N3301A-01A

N3301A Electronic Load Half Rack Mainframe

CC Source Regulation Out Of Specification

Situation:**CC Source Regulation problem**

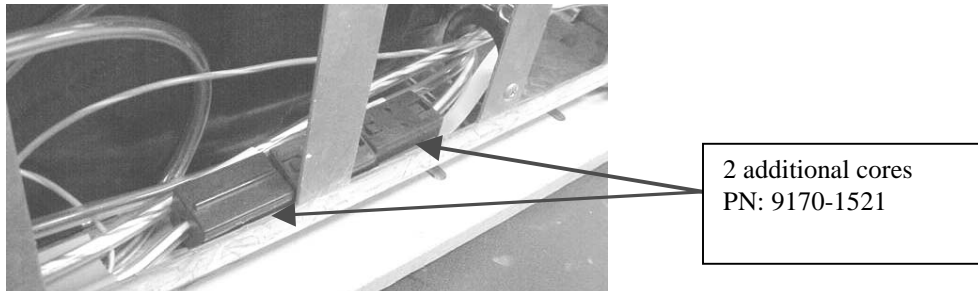
The N3301A mainframe does not meet its CC source regulation specification. The mainframe has a bulk supply which is measuring 318mVp-p common mode noise, the actual specification of this supply is 280mV. To correct the common mode noise problem two additional ferrite clamps (9170-1521) will be added to the output of the bulk supply. By doing this the N3301A will now meet the CC source regulation specification.

2. Open the side panel cover and install the clamp-on ferrite core PN: 9170-1521 qty 2 side by side to the existing core on the cable.
